## **Agenda Item: Update on Hylton Martin Application 2014-621**

**Re: Fullwood Station Rezoning Re-Submittal**

FULLWOOD STATION TTM  
MATTHEWS, NC

Figure 4

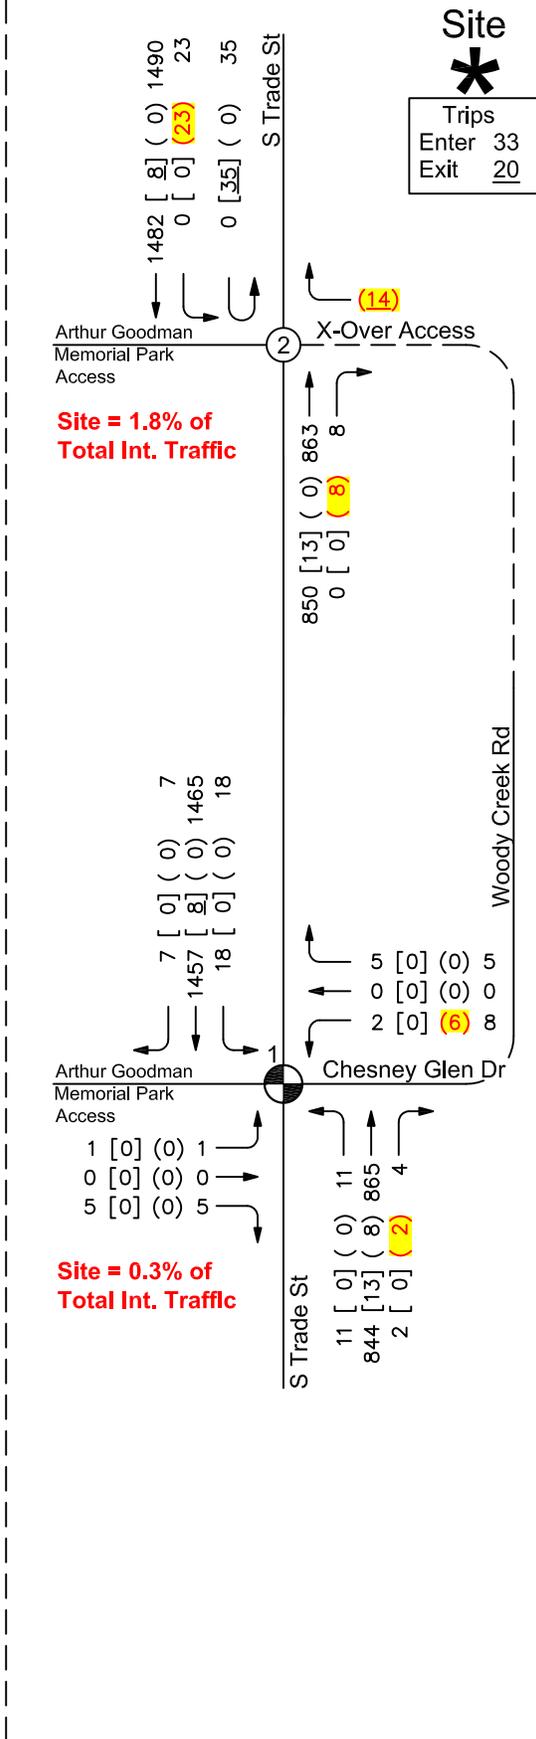
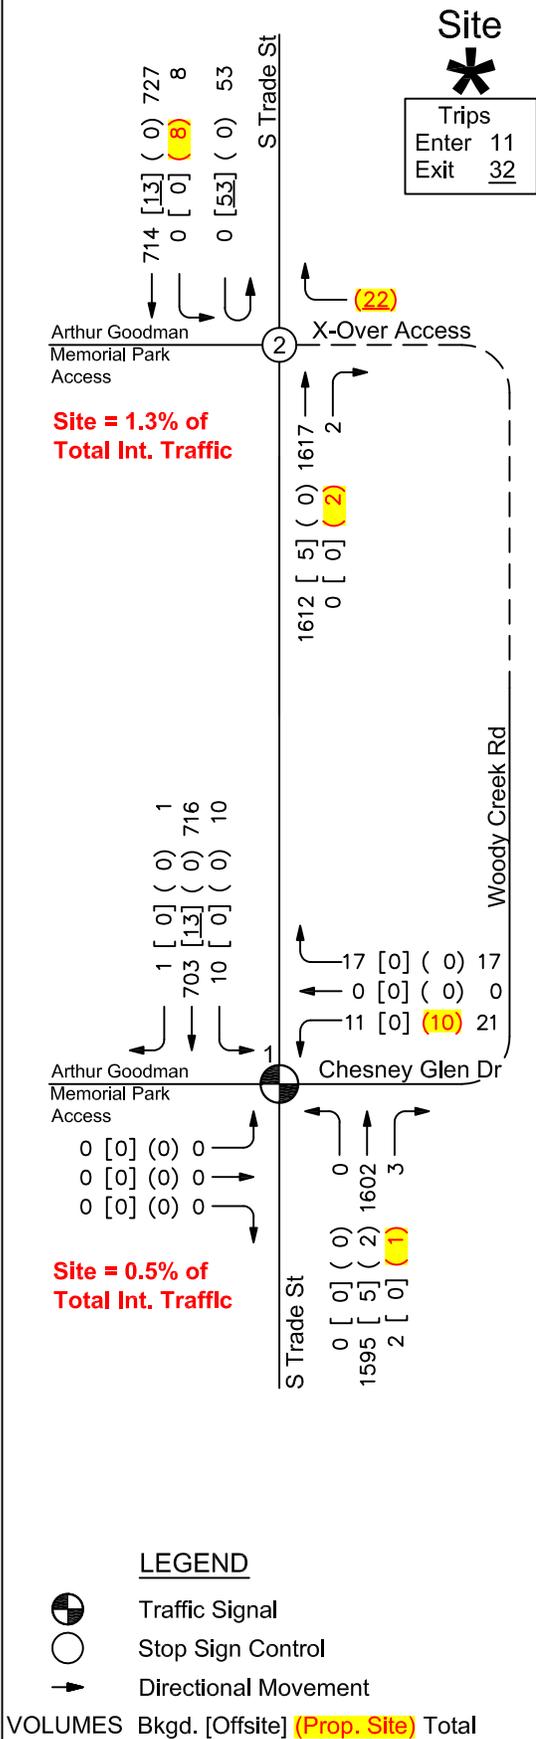
2. Off-Peak traffic counts requested.

**RESPONSE:** Off-peak traffic counts attached as part of this document.
